LINCOLN CITY/LANCASTER COUNTY PLANNING STAFF REPORT

for March 16, 2005 PLANNING COMMISSION MEETING

P.A.S.: Whitetail Run
Preliminary Plat # 04031

PROPOSAL: A preliminary plat for 9 acreage residential units.

WHITETAIL RUN

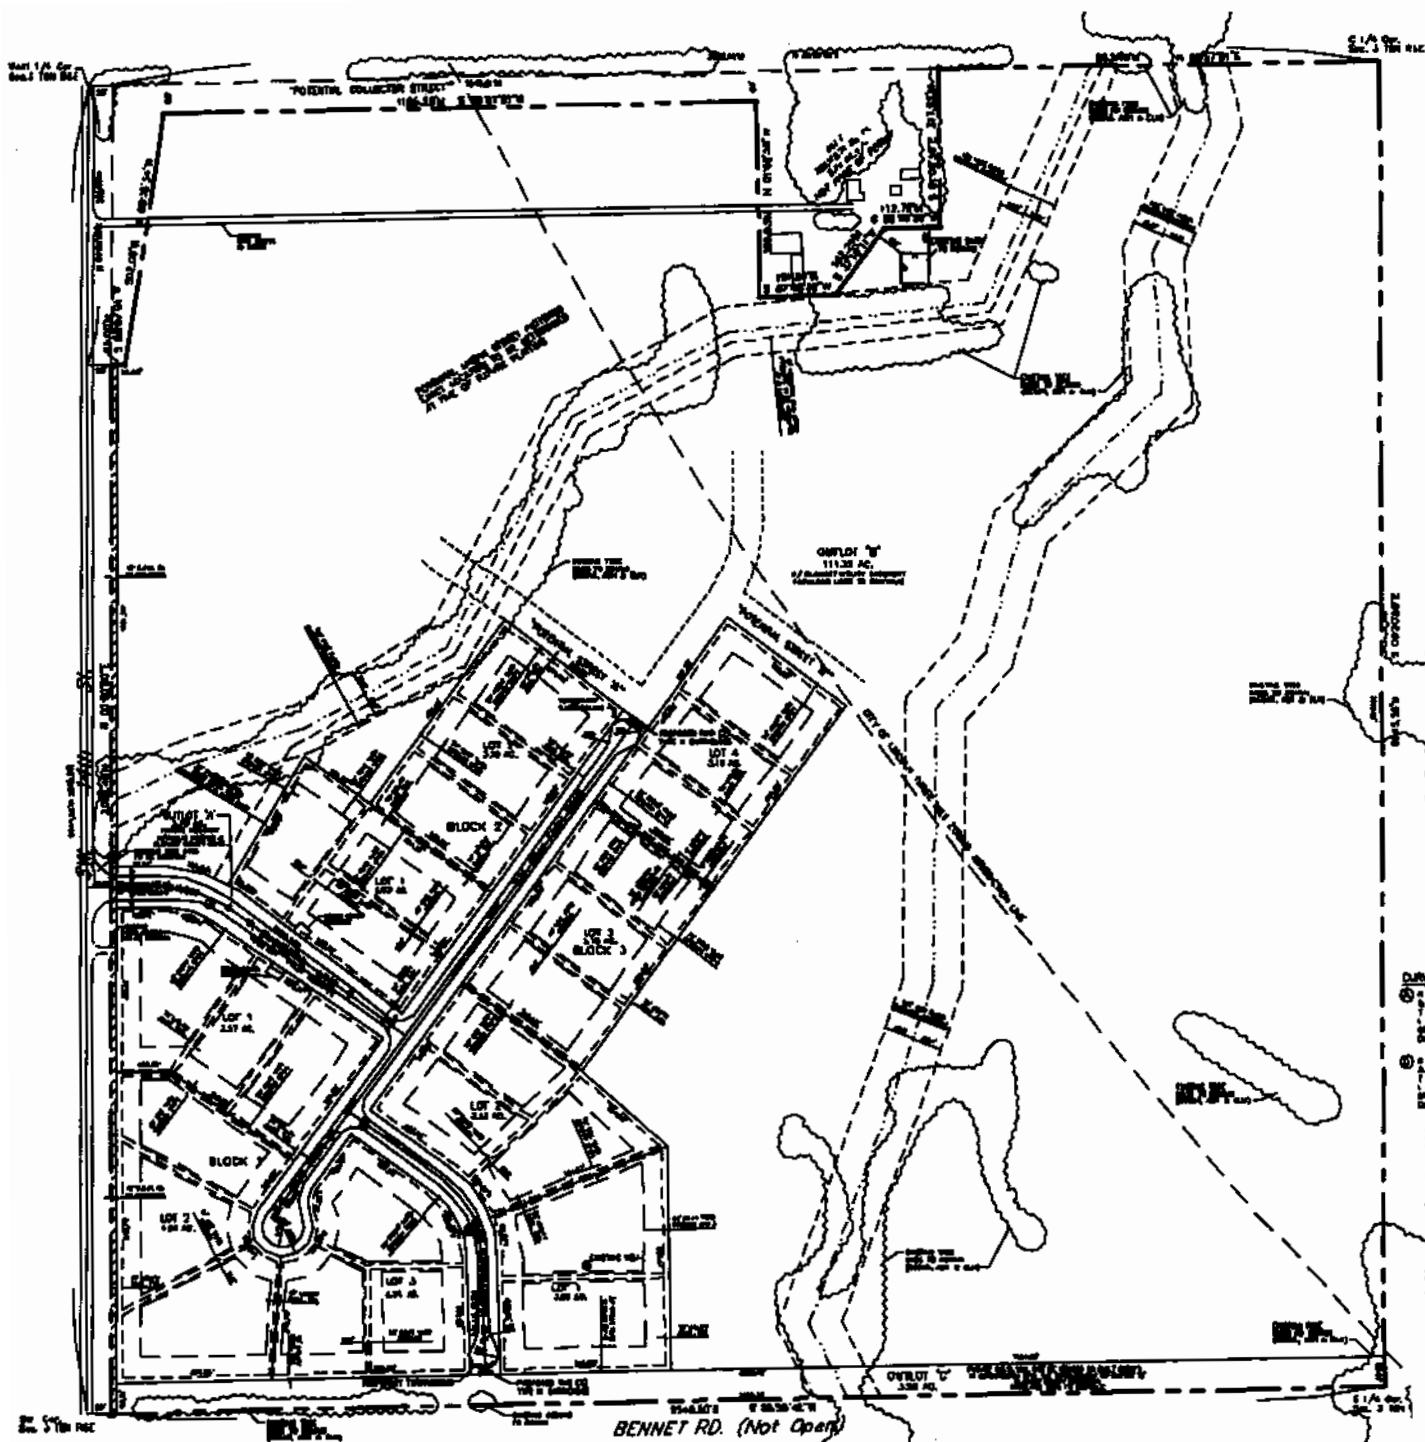
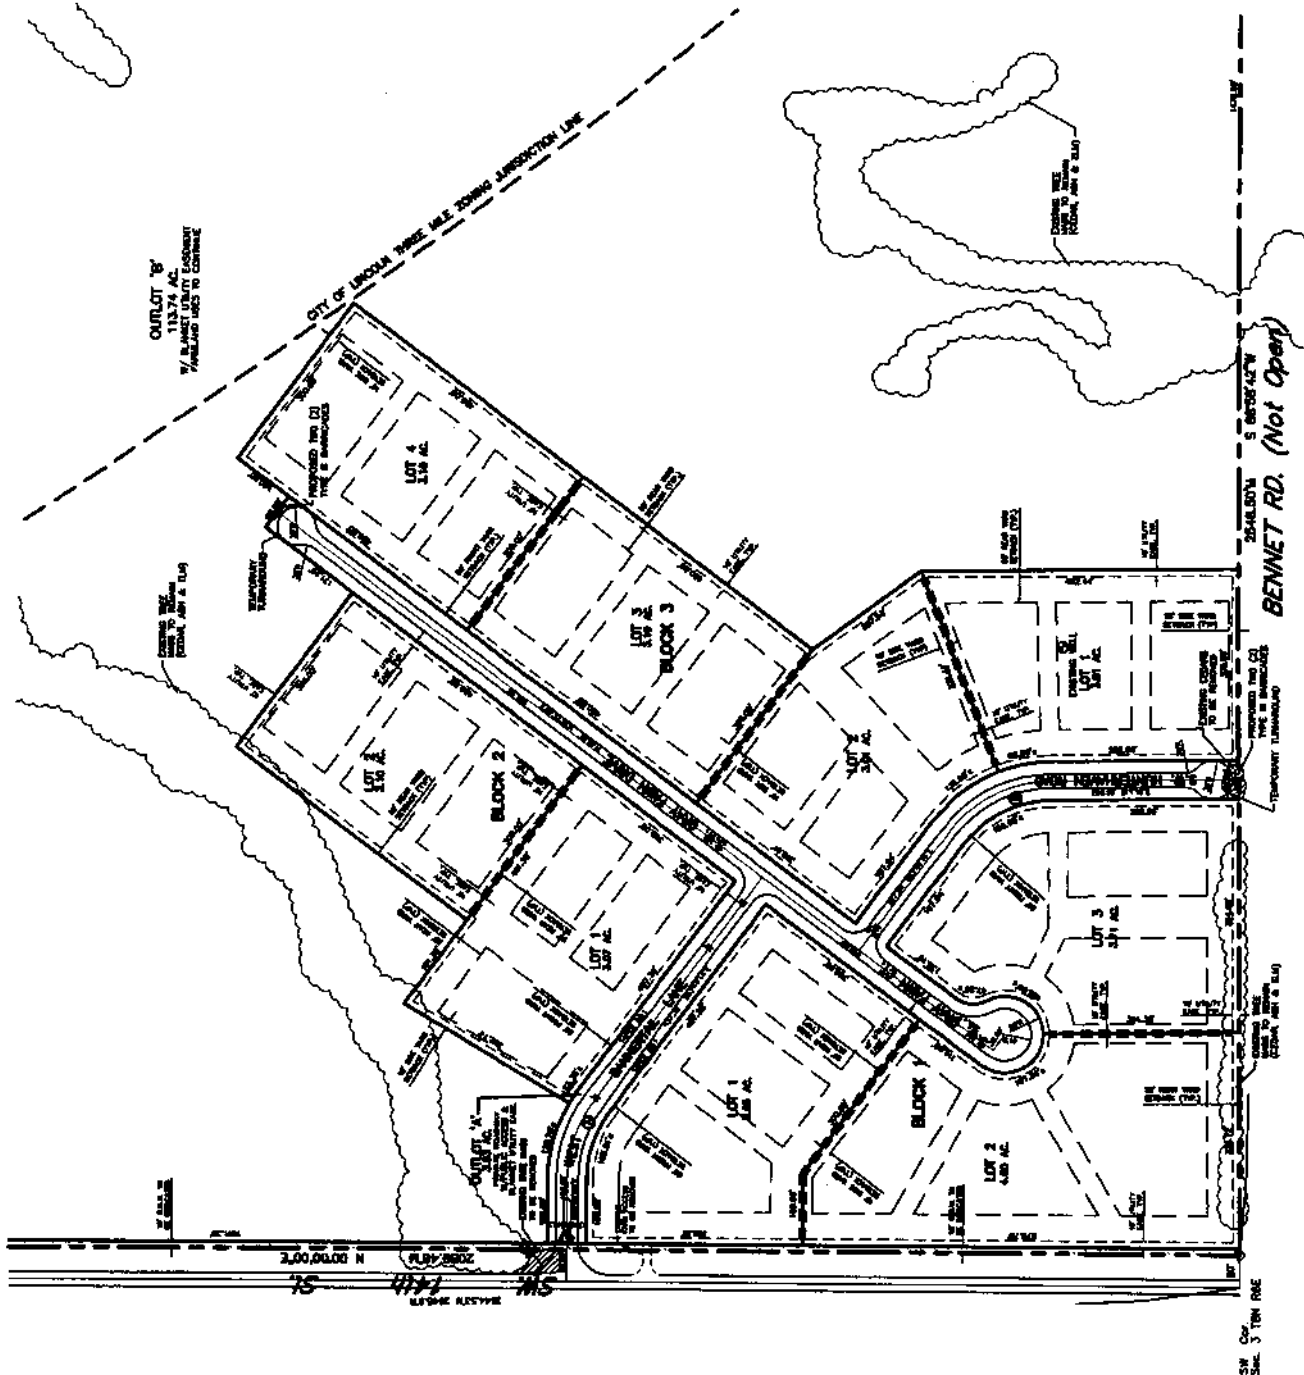
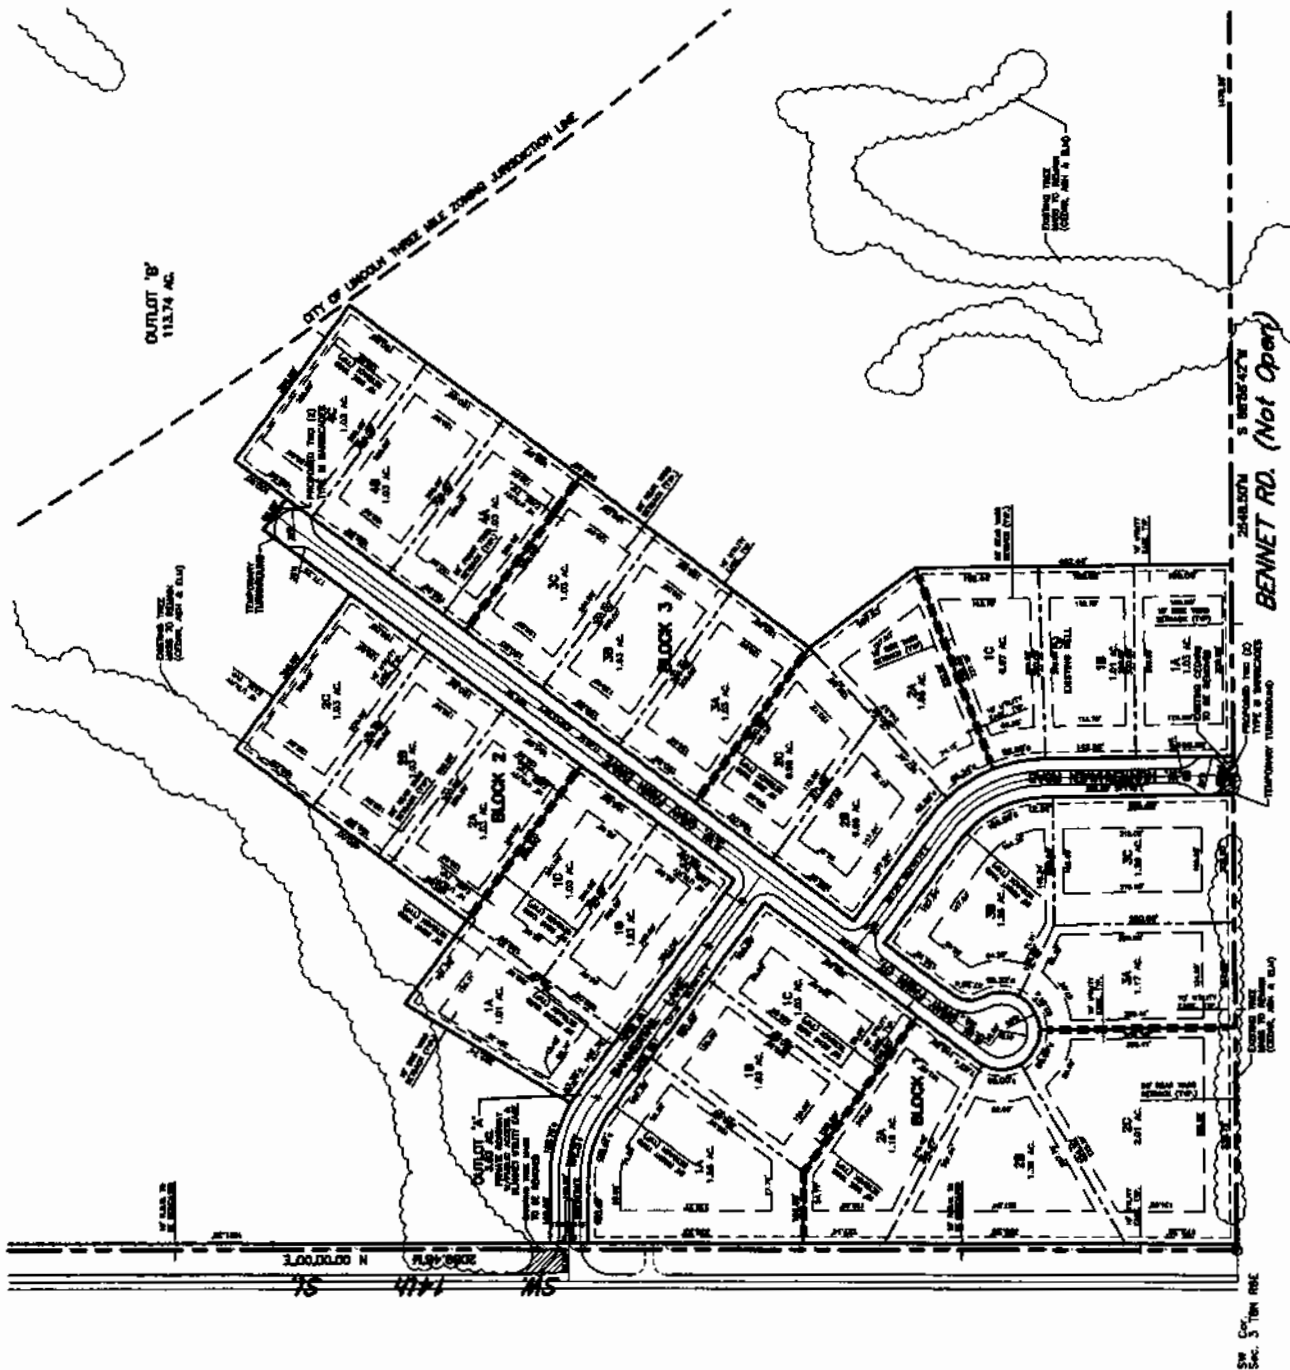
1. Make the revisions noted in the County Engineers letter of Dec. 6, 2004.
2. Make the revisions noted in the Public Works memo of December 30, 2004.
3. Add "with BTA" to the Title Block of Page 1

4. Amend Note #2 to reflect 2 outlots (three if Bennet Road is added)
5. Amend Note #3 to reflect CUP with Build Through overlay and the bonus is provided for provision of future urban subdivision, as well as farm preservation in the County.

6. Amend Note #8 to reflect the "Rural Public and Intermediate BTA Standard".
7. Revise Note 15, block length waivers are needed on the west and may be needed on S.W. Gray Fawn Drive.

13. Add a note that only one main building in a building envelope is allowed per platted lot.
14. Show a future street or pedestrian walk (as required) in Block 3 in the area of Lots 3 and 4 and show by a dashed line the street extension and cross street at the north end of Lot 4, Block 3.

15. Provide a front yard setback at the north end of Lot 4, Block 3 if a cross street is shown at this location (the road will require rough grading).
16. Show easements for the smaller BTA parcels in each lot.

17. Show an Urban Framework Master Plan for Outlot B, per 27.65.075 (c).
18. Show a blanket easement or a delineated easement for future major utilities in Outlot "B".

19. Show an Out Lot for the future mile section road on Bennet Road. Note that this will not be graded or built except in conjunction with the development of Outlot "B".

1. County Engineers letter of December 6, 2004.
 1. General Note #14 has been revised to state "Only one residential driveway access shall be permitted per each lot."

2. General Note #20 has been added to Sheet 1 of 4 to state "Developer shall be responsible for installing street identification signs, one "Stop" sign and one "No Outlet" sign."

3. General Note #21 has been added to Sheet 1 of 4 to state "Developer shall install sediment control on all new construction."
 4. A 24" CMP culvert has been shown under West Bannertail Lane to drain the natural low area.

3. "with BTA" has been added to Title Block of Sheet 1 of 4.
4. Outlot 'C' has been added for future Bennet Road. General Note #2 has been shown with 3 outlots.

5. General Note #3 has been modified to reflect "CUP with Build Through overlay and the bonus is provided for provision of future urban subdivision, as well as farm preservation in the County.

6. General Note #8 has been modified to include "Rural Public and Intermediate BTA Standard".
7. General Note #15 has been modified to include block length waiver on the west perimeter of the plat.

13. General Note #2 states that "Each lot shall contain a maximum of one single family residence and out buildings".
14. A 5' pedestrian easement has been shown to the south of the property line between Lots 3 and 4, Block 3.

15. A front yard setback has been shown on the north end of Lot 4, Block 3 and Lot 2, Block 2 do to the potential cross streets shown. The required grading adjacent to the lots has been shown on the Grading Plan.

16. 10' wide utility easements have been added centered on the build through lot lines.
17. A potential urban street pattern has been shown on the plans for Outlot 'B'.
